**BEFORE THE PUBLIC UTILITIES COMMISSION
OF THE STATE OF SOUTH DAKOTA**

**IN THE MATTER OF THE
APPLICATION OF SWEETLAND
WIND FARM, LLC FOR FACILITY
PERMITS FOR A WIND ENERGY
FACILITY AND A 230-KV
TRANSMISSION FACILITY IN HAND
COUNTY, SOUTH DAKOTA FOR THE
SWEETLAND WIND FARM PROJECT**

**APPLICANT’S RESPONSES TO
STAFF’S FIRST SET OF DATA
REQUESTS TO APPLICANT**

EL19-012

G:\Projects\21SD\5372\MXD\Sound\5-2_Sound_Level_Modeling_Results_20190523_v2.mxd

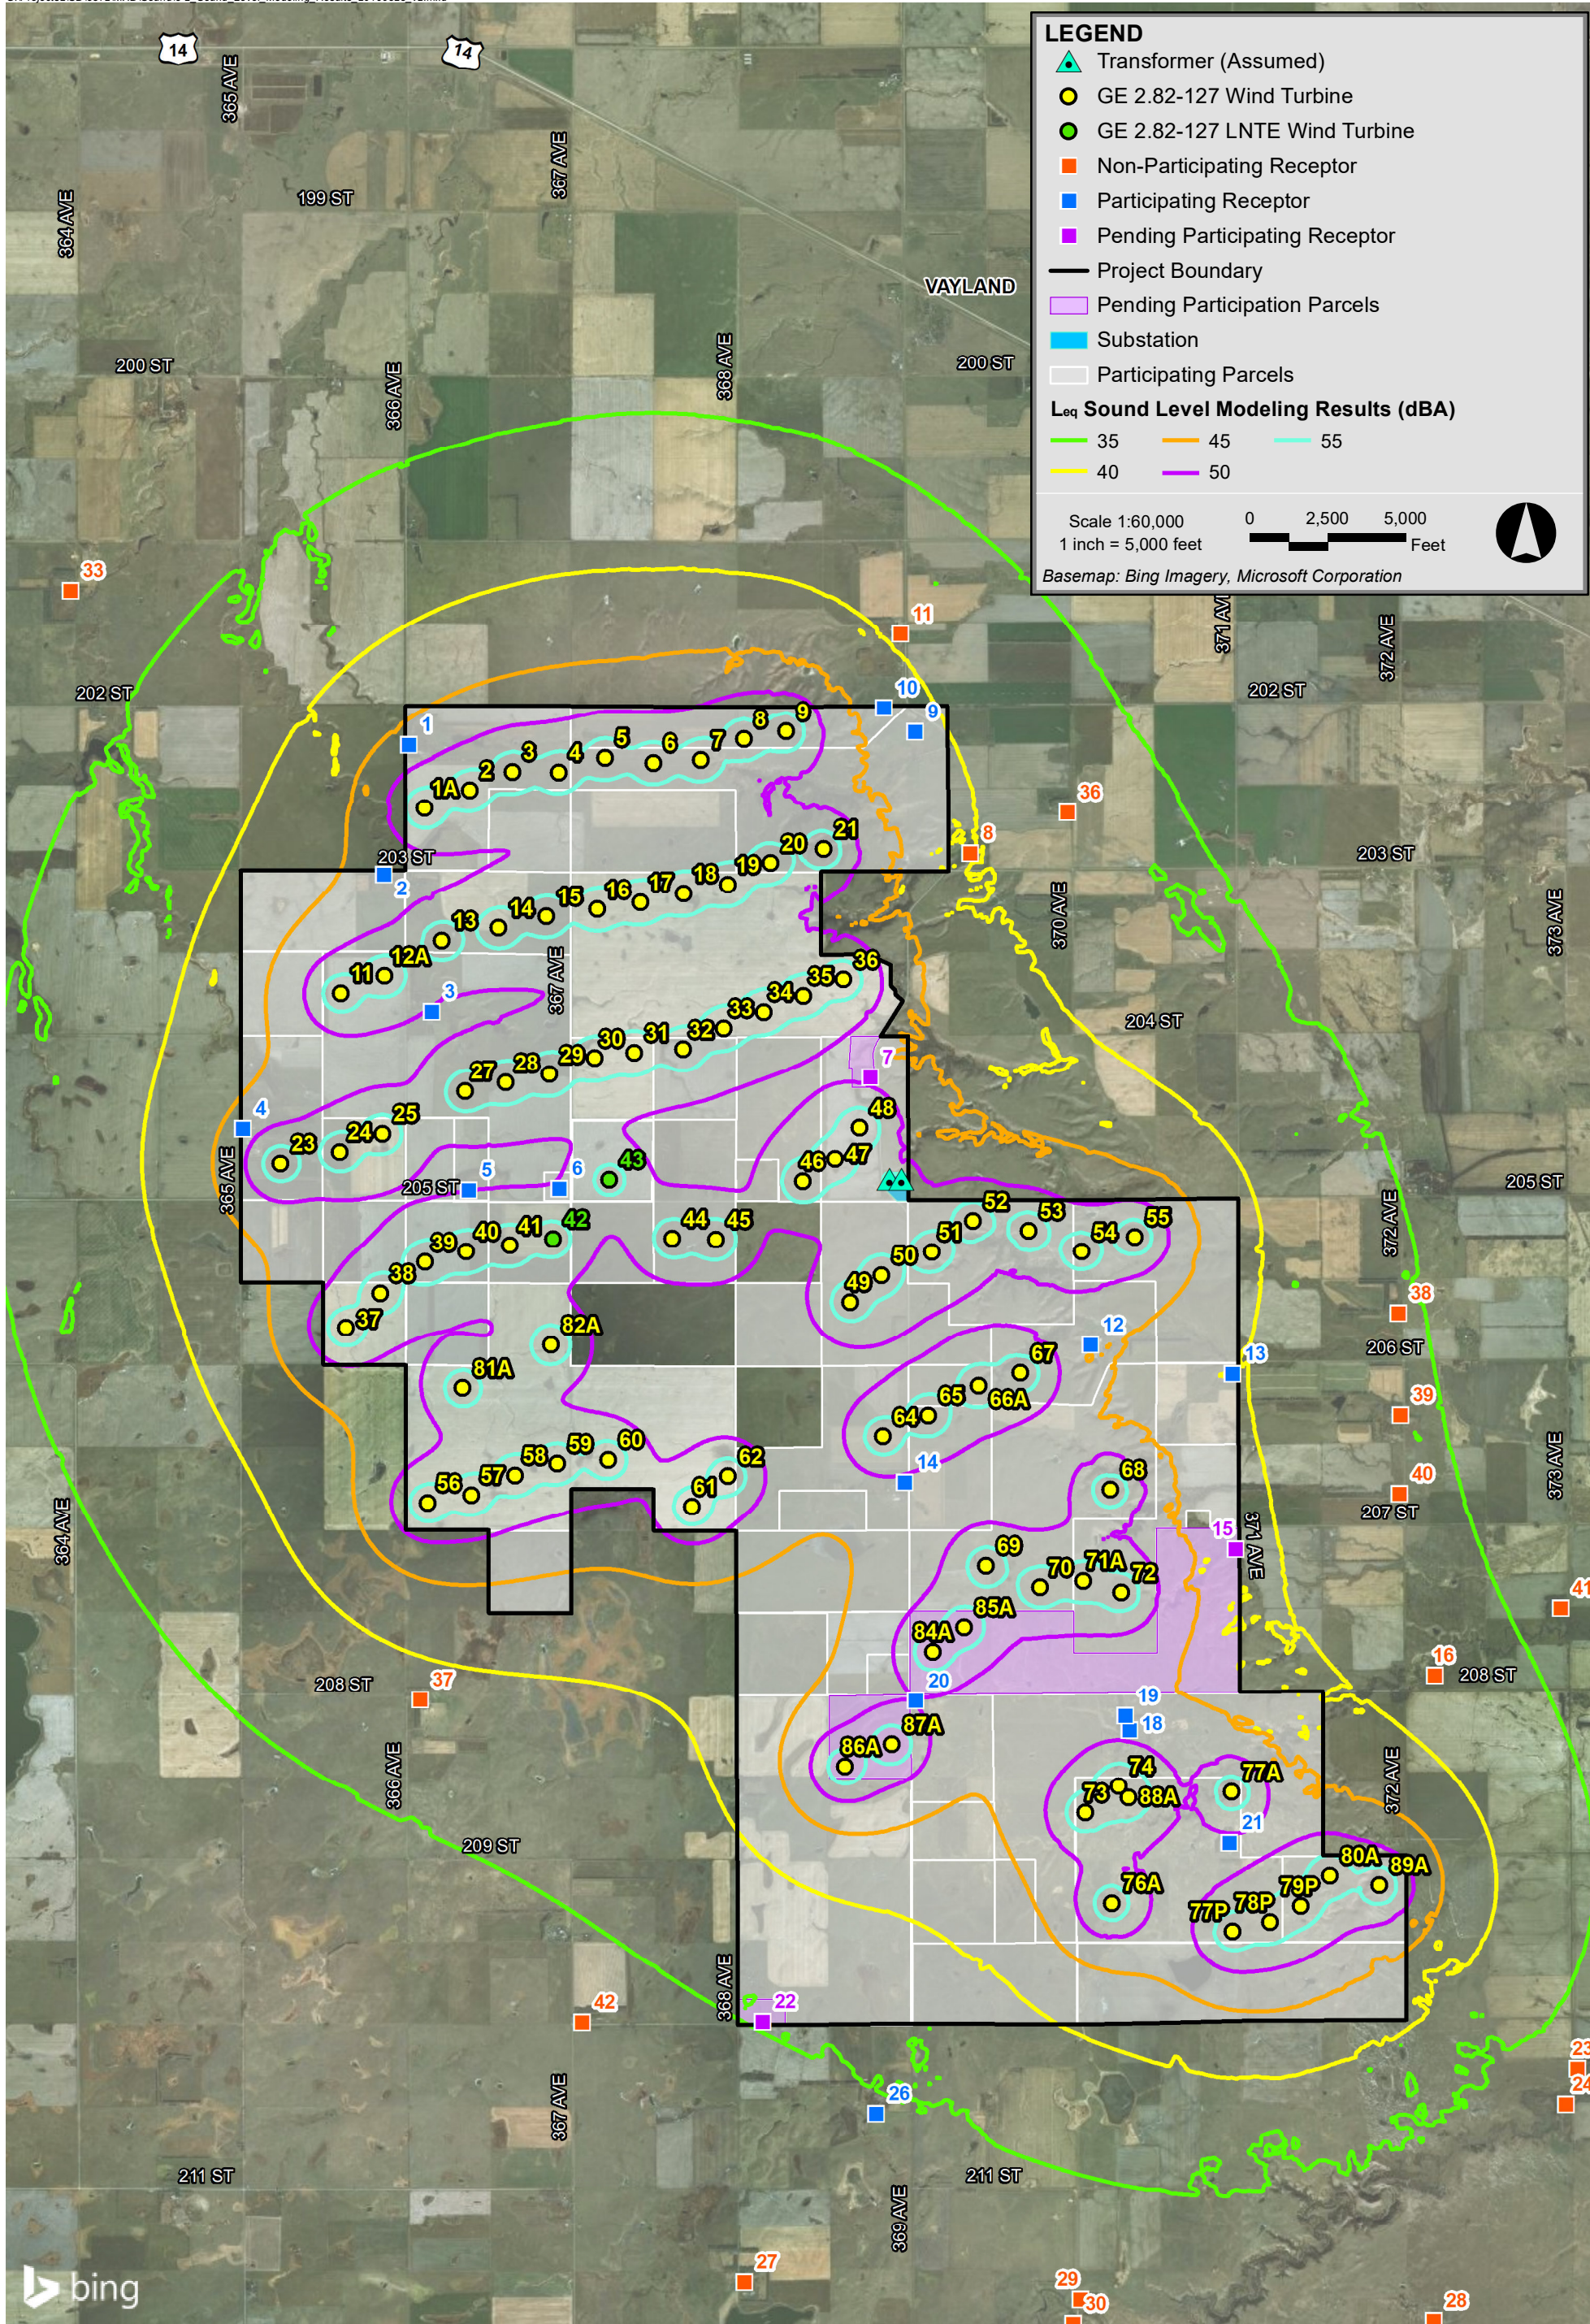
1-36) Refer to Appendix L of the Application, Sound Study, Figure 5-2. Please provide a revised Figure 5-2 with turbine locations 10 and 22 eliminated. Provide the expected sound level at receptors 8 and 11 with these turbine locations eliminated.

If turbines 10 and 22 were eliminated, the sound modeling results are as follows:

- Receptor 8: The modeled sound level would change from 43 dBA to 40 dBA under the modeling parameters utilized by Epsilon (which are more conservative (by approximately 2 dBA) than those utilized by Mr. Hessler in prior dockets).
- Receptor 11: The modeled sound level would change from 42 dBA to 39 dBA under the modeling parameters utilized by Epsilon (which are more conservative (by approximately 2 dBA) than those utilized by Mr. Hessler dockets).

See also Attachment 1-36. Sweetland does not support the removal of turbines 10 and 22 because:

Figure 5-2
Leq Sound Level Modeling Results (Wind Turbines 9, 10, 21, and 22 Removed)

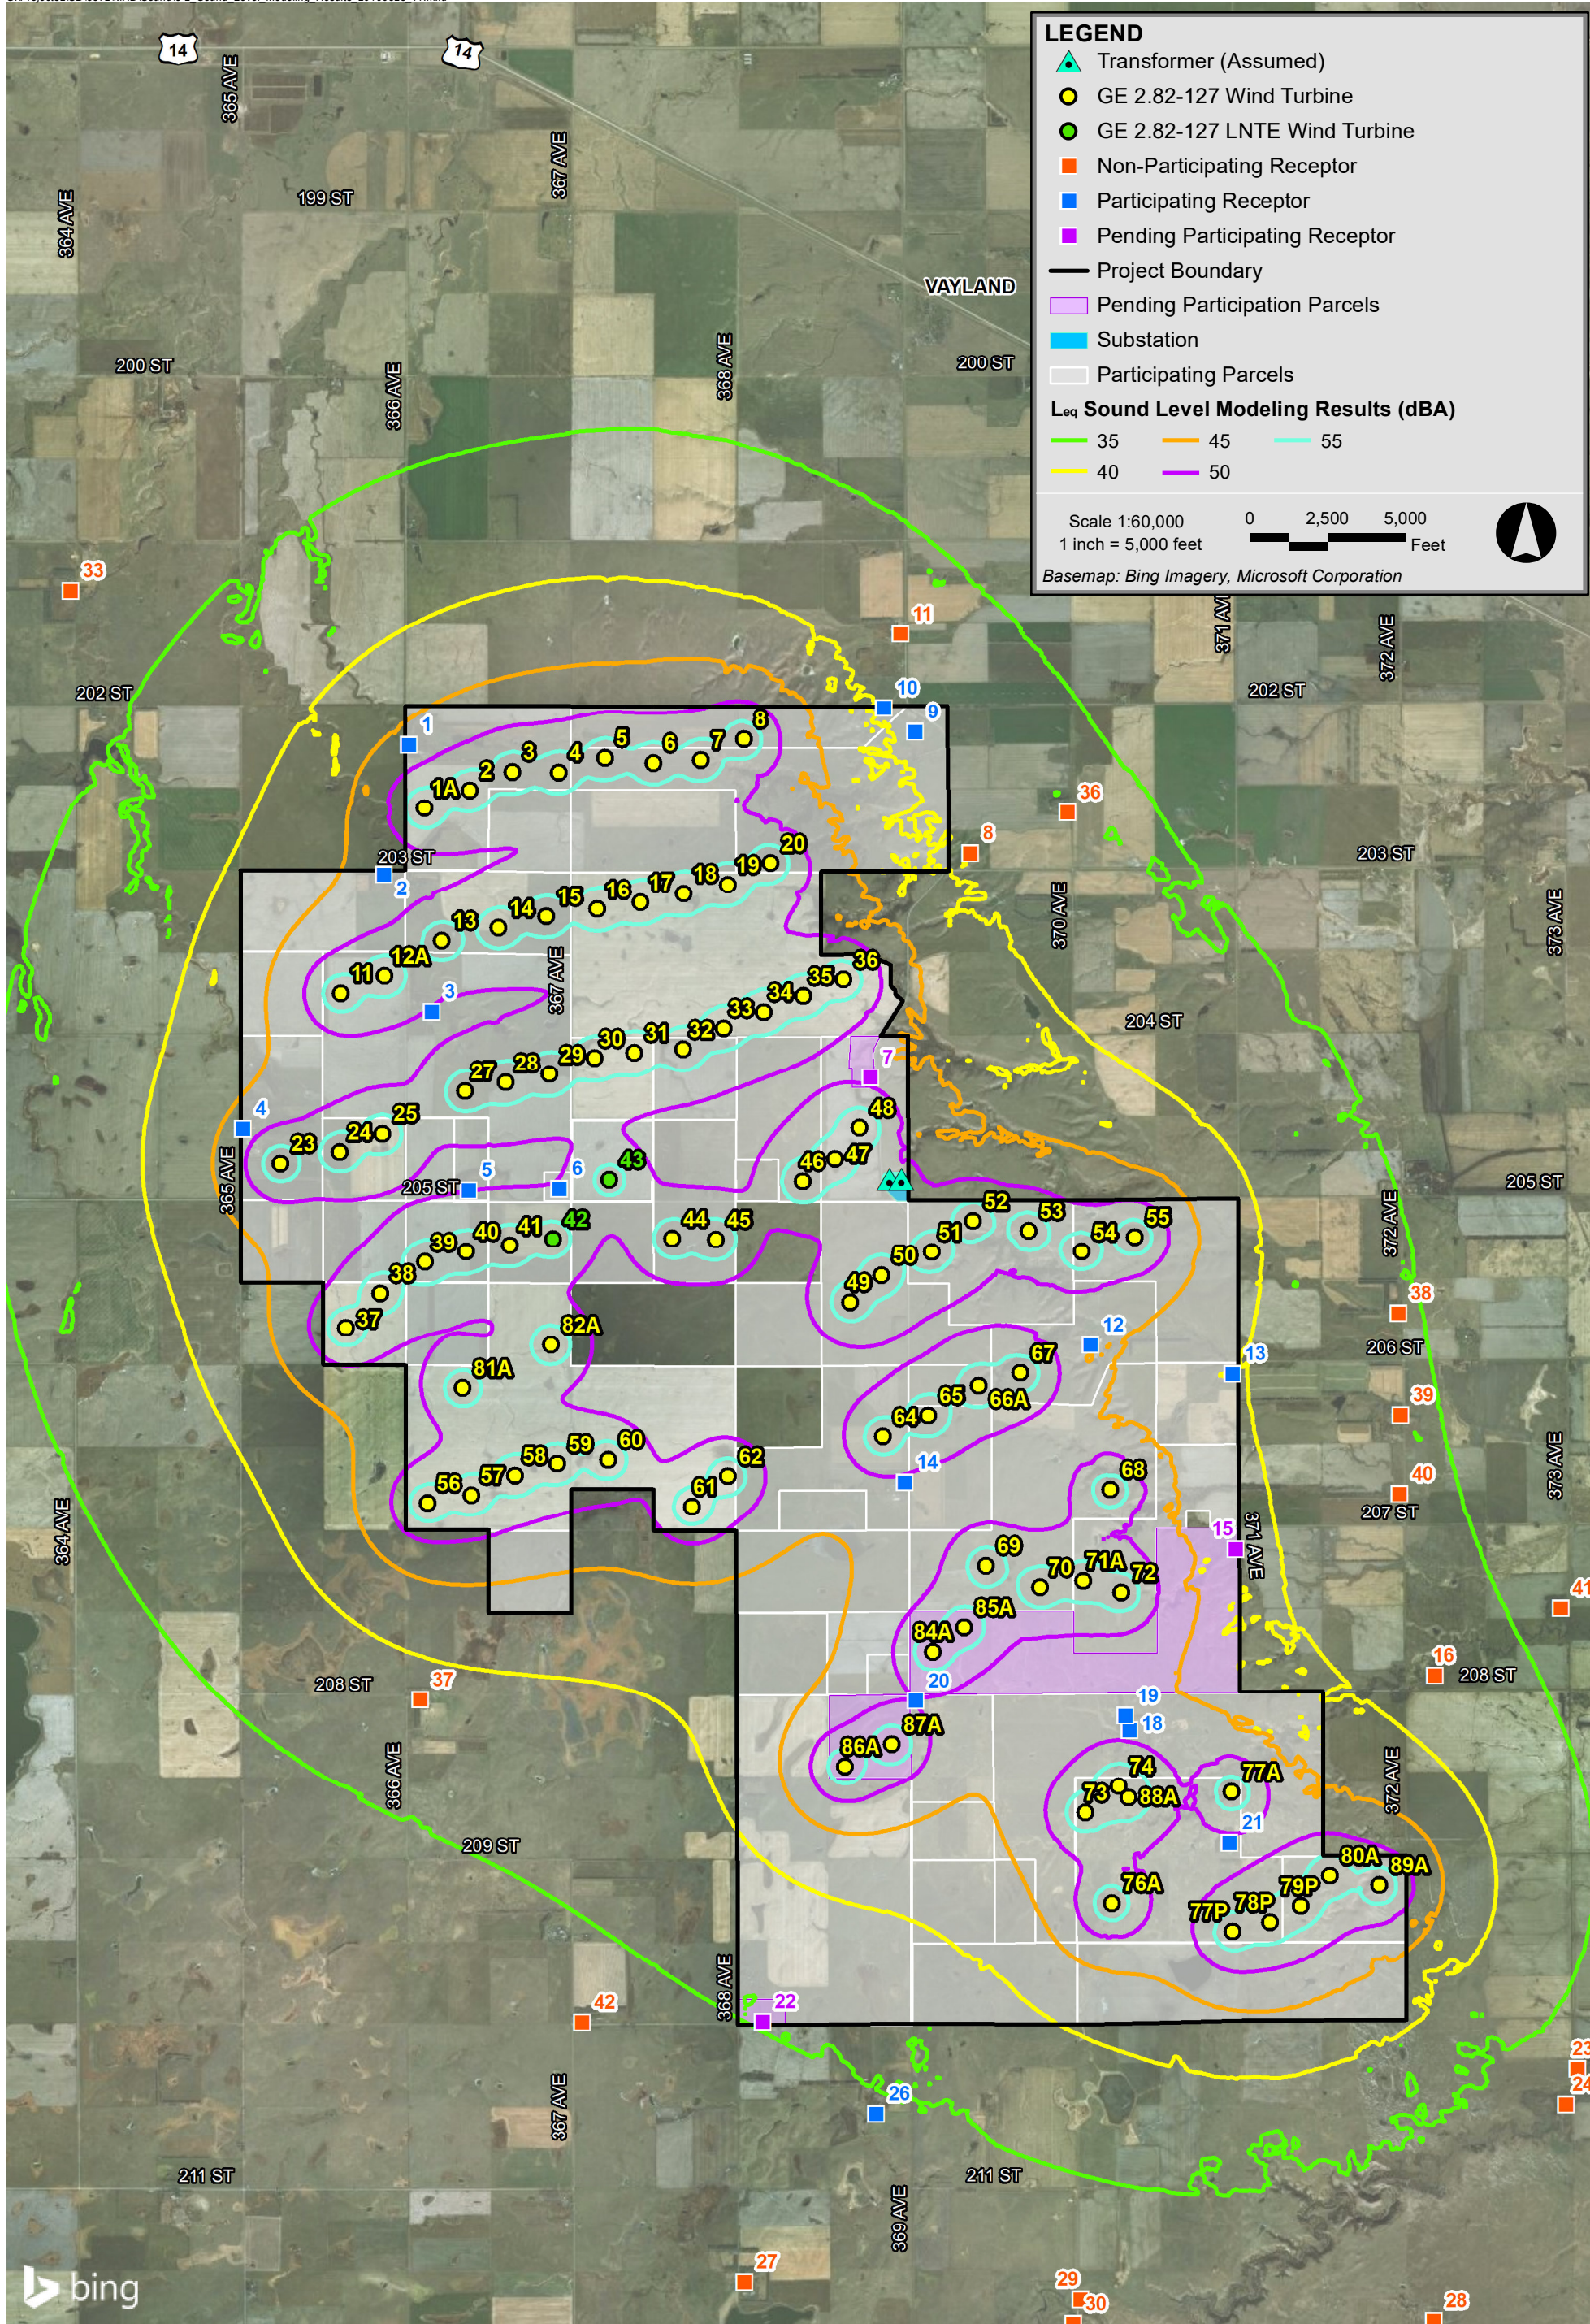
- 1-37) Refer to Appendix L of the Application, Sound Study, Figure 5-2. Please provide a revised Figure 5-2 with turbine locations 9, 10, 21 and 22 eliminated. Provide the expected sound level at receptors 8 and 11 with these turbine locations eliminated.

If turbines 9, 10, 21, and 22 were eliminated, the sound modeling results are as follows:

- Receptor 8: The modeled sound level would change from 43 dBA to 39 dBA under the modeling parameters utilized by Epsilon (which are more conservative (by approximately 2 dBA) than those utilized by Mr. Hessler in prior dockets).
- Receptor 11: The modeled sound level would change from 42 dBA to 38 dBA under the modeling parameters utilized by Epsilon (which are more conservative (by approximately 2 dBA) than those utilized by Mr. Hessler in prior dockets).

See also Attachment 1-37. Sweetland does not support the removal of turbines 9, 10, 21, and 22 because:
